产品开发更改

DC No. / 开发更改编号: RBCE-PDECR2026003

Customer project Name/ 客户项目名称:	JP360	MCR No. / MCR号:	
Affect Product No. / 产品号:	F03ZS0000B-04	Component No. / 零部件号:	F03Z20088M-00
Sample type / 样品类型:	☐ A ☐ B ☐ C ☒ FD	Initiator/发起人:	lu feihong
Reason of changes / 更改理由:

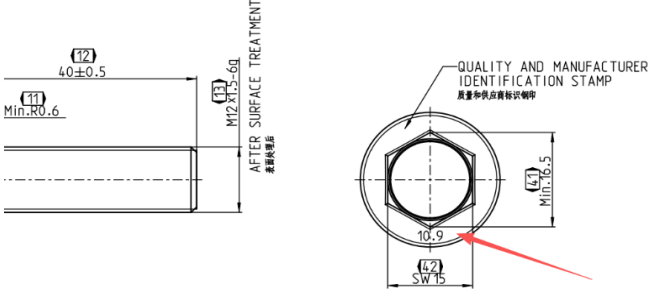
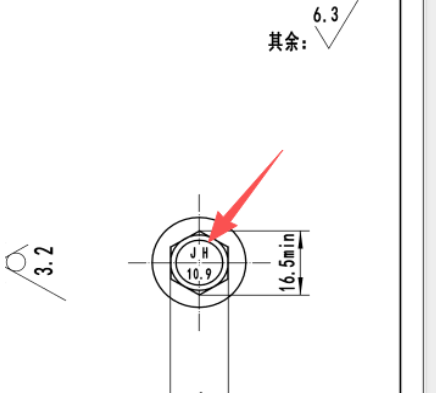
螺栓增加二供供应商, 新增二供螺栓料号及图纸, F03Z20088M-00, 该二供料号图纸与一供图纸区别为,质量和供应商标识区域调整

当前设计	更改建议	备注
		新增螺栓供应商, 新螺栓图纸调整二供供应商质量和供应商标识, 其余尺寸未作更改
当前设计是标识打在螺栓法兰处	更改后标识打在螺栓头部
